# Access Compliance Report Public Rights-of-Way (Curb Ramps)

Main Street: CHRISTY\_LN Cross Street: TIGERTAIL\_DR Location: NE

ADA ID: RPRK211207131457 Ramp Type: Type 4 - Parallel Initial Pass/Fail: Fail Overall Compliance: No Severity Score: 30

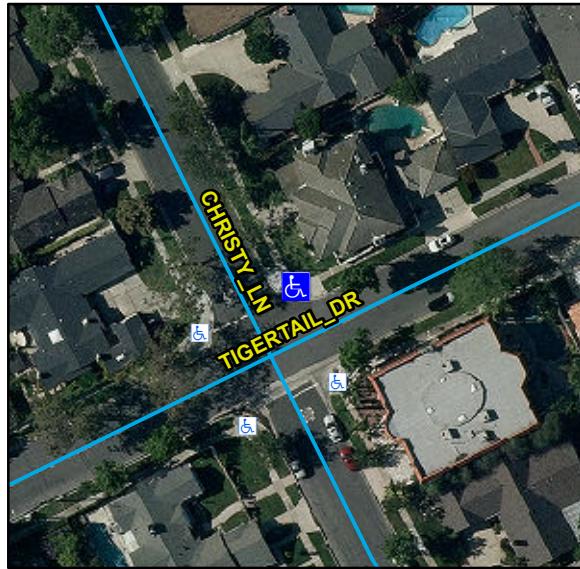
| Compliance | Description                   | Data       | Compliance | Description                   | Data |
|------------|-------------------------------|------------|------------|-------------------------------|------|
| No         | Ramp Cross Slope LT (%)       | 3.2        | No         | Ramp Cross Slope RT (%)       | 7.9  |

**Remove & Replace Curb Ramp With Two New Directional Ramps or Equivalent.**

**R304.5.3, STD 1115**
